Daly Unit No. 5
PM Application.

Re: Board Order No. PM 63
Modification of Daly Unit No. 5 Pilot Waterflood

RE: Board Order No. PM 63 - Daly Unit No. 5
Daly Lodgepole D Pool - Pressure Maintenance
Maximum Allowable Wellhead Pressure

Re: Daly Unit No. 5
Maximum Wellhead Injection Pressure

FIGURE 1

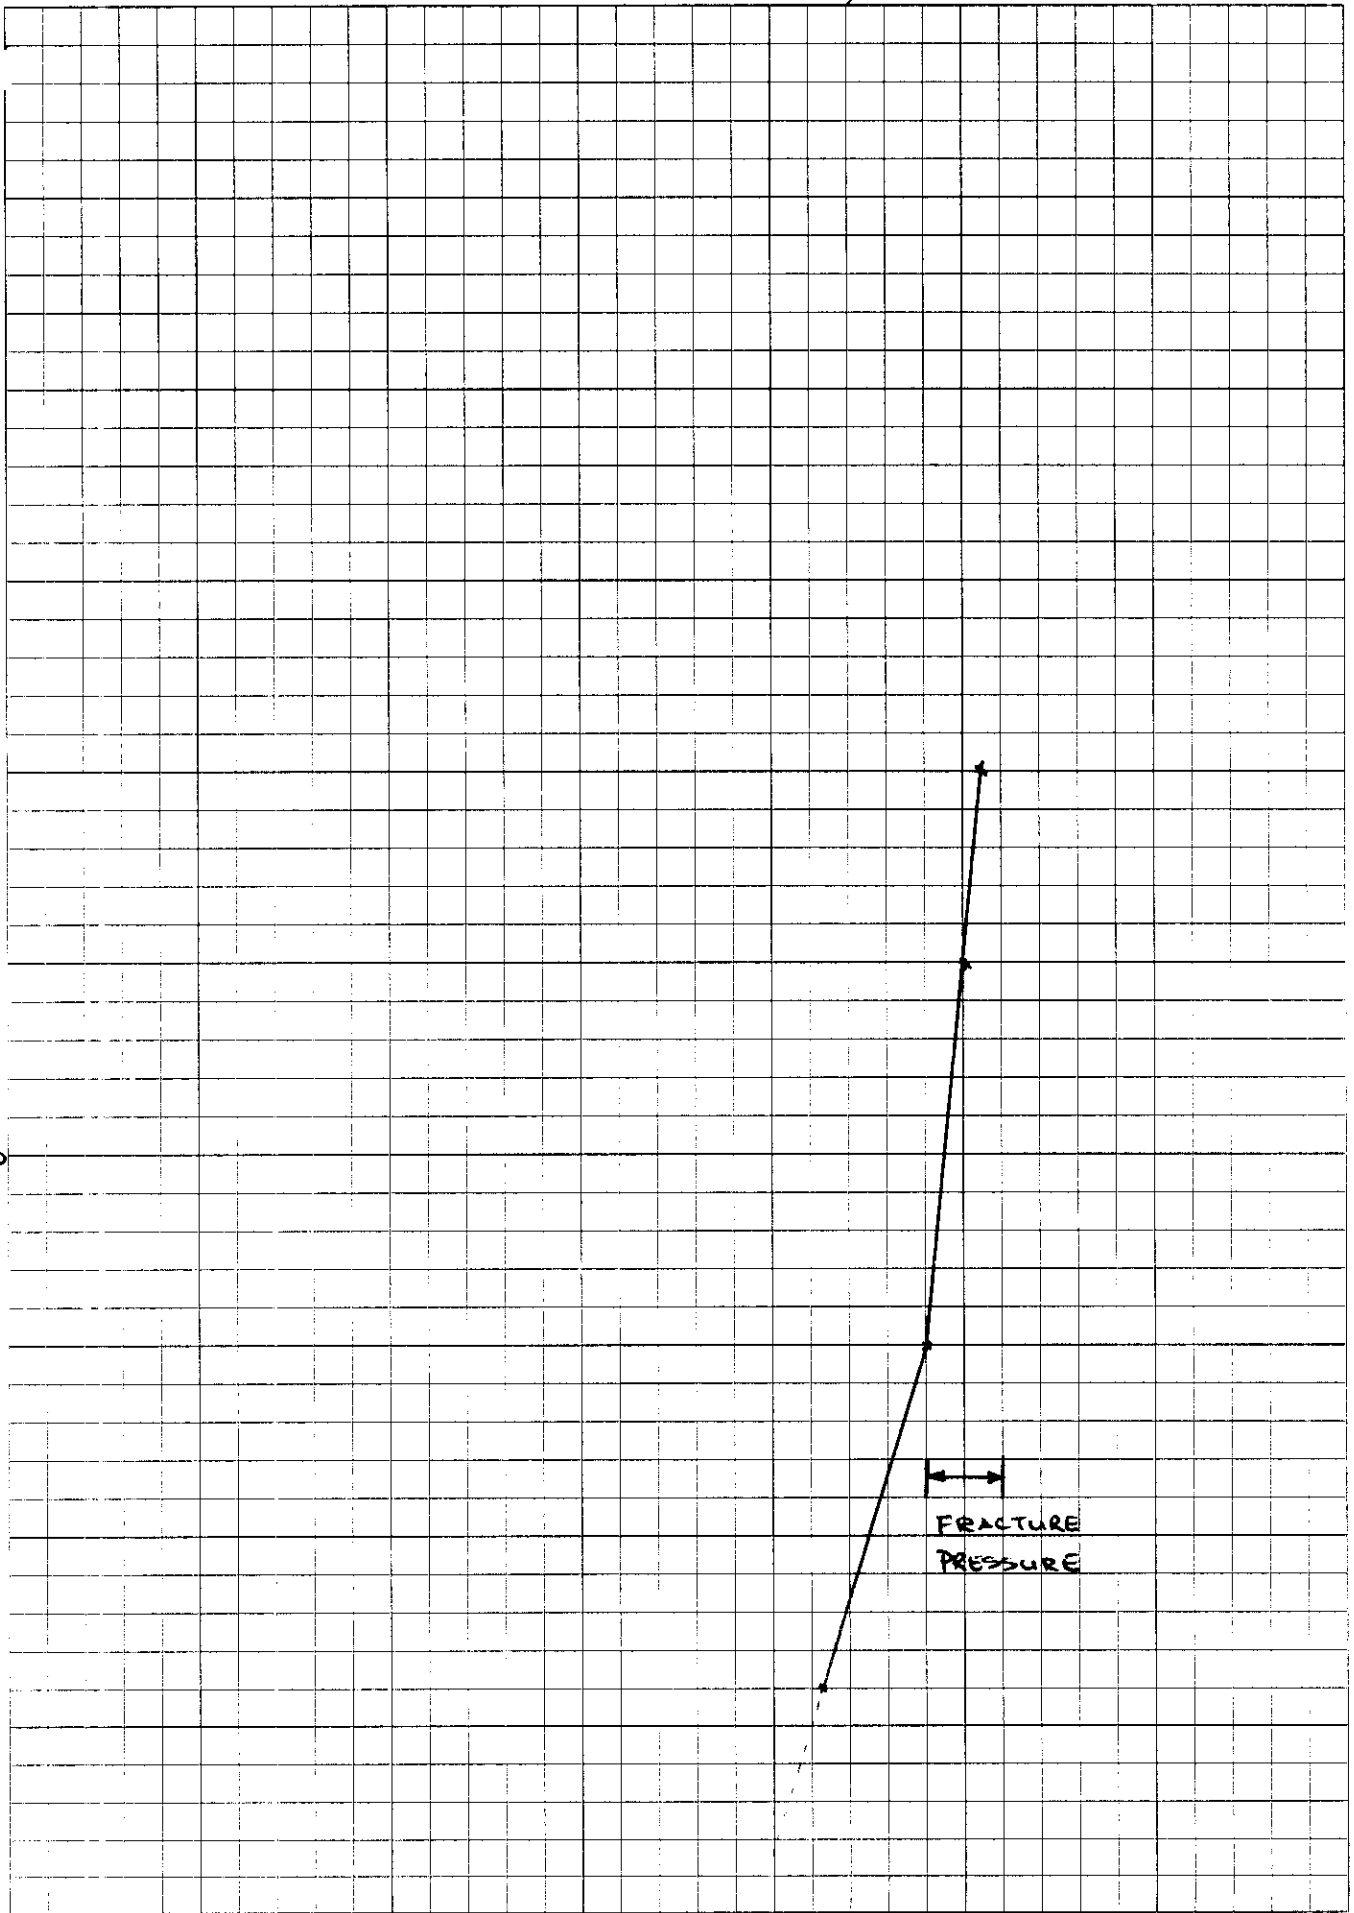
Rideau commenced water injection into 9D-28-9-29 in March, 1991. The average injection rate at the approved maximum wellhead injection pressure of 8 500 kPa (Board Order No. PM 63) was 6.0 m³/d, slightly greater than reservoir voidage. Rideau gradually increased the injection pressure during April and May, 1991 to 10 200 kPa resulting in an increase in injectivity to 30 m³/d (Figure 1).

One of the reasons previous waterfloods in the Lodgepole Formation in Twp. 9-29 (WPM) failed, was insufficient injection volumes. At an injection rate of 6.0 m³/d it would take in excess of 30 years to achieve reservoir fill-up. Increasing the maximum wellhead injection pressure to 10 300 kPa will allow reservoir fill-up to be achieved in less than 3 years.

There is a risk that injection near the fracture pressure, estimated at 9 600 to 10 400 kPa, will result in the formation being fracture causing out of zone injection. However, to properly evaluate the feasibility of waterflooding the Daly Lodgepole D Pool, it is necessary to achieve reasonable injection rates, even at the expense of out of zone injection. Therefore, it is recommended that the application be approved.

It is recommended that the Board approve Rideau's application. The proposed Board letter of approval is attached.
